Early Neighborhood Notification for the 60% Review of the Ft Marcy Pickleball Courts

FORT MARCY PARK - PICKLEBALL COURTS DESIGN
CITY OF SANTA FE
FORT MARCY PARK, SANTA FE, NM 87505

City of Santa Fe – Fort Marcy Park Pickleball Courts

Presentation January 11, 2024

Overall Site Plan

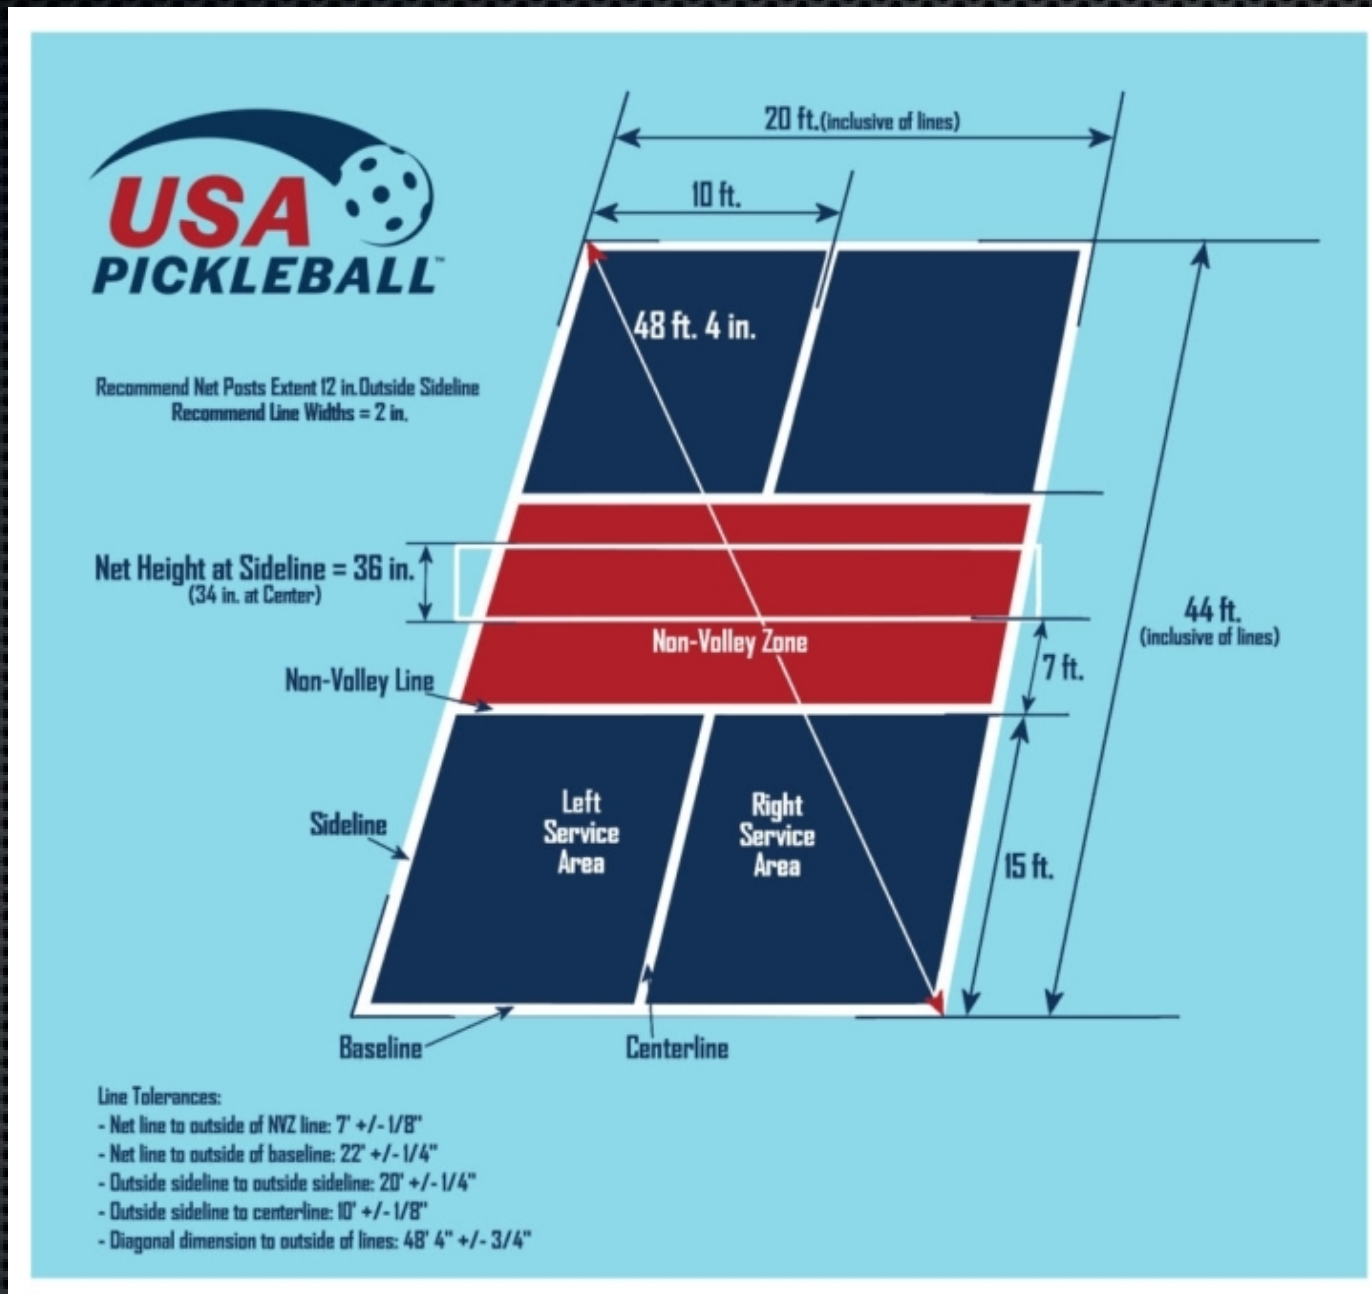
Can the play area be 34-foot by 64-foot instead of the 30 by 60 shown on the preliminary plans?

Can the steps and the ramp be moved to the southeast corner of the new courts so players can move more easily between the courts?

Can new bathrooms be installed?

The drawings will be revised to include courts with the 34-foot by 64-foot play area required for tournaments under USA Pickleball Association rules.

The ramp and stairs have been moved to the southeast corner.

New bathrooms will not be installed as part of this project. The plans include a concrete slab near the southwest corner of the existing pickleball courts where portable toilets will be placed and more-easily maintained.

Electrical Schematic

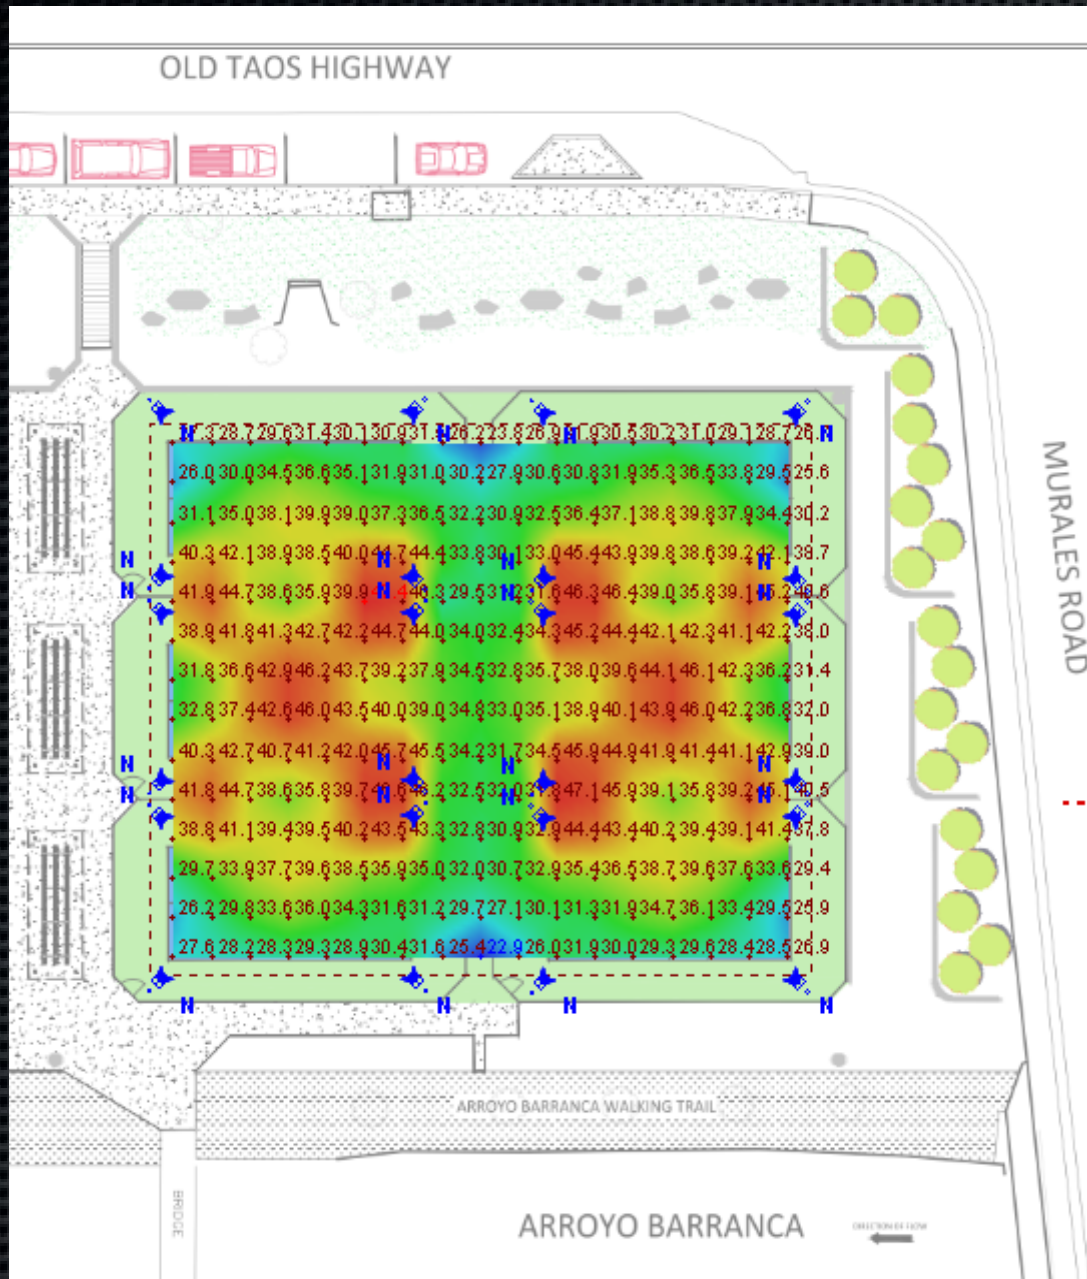
Can there be an electrical outlet installed?

Can lighting be installed so the courts can be used at night?

Can the lighting be installed so that it is not glaringly bright for nearby residents?

The plans will include a 120-volt electrical outlet near the bleachers.

The design includes lighting. It may be identified as a “future improvement” if money is not available in Phase 1.

The light poles will be only 20 foot tall. The light will be directed downward at the courts and will be shielded to minimize any backlight from shining on adjacent properties. The sunken court design will also shield adjacent properties from court lighting.
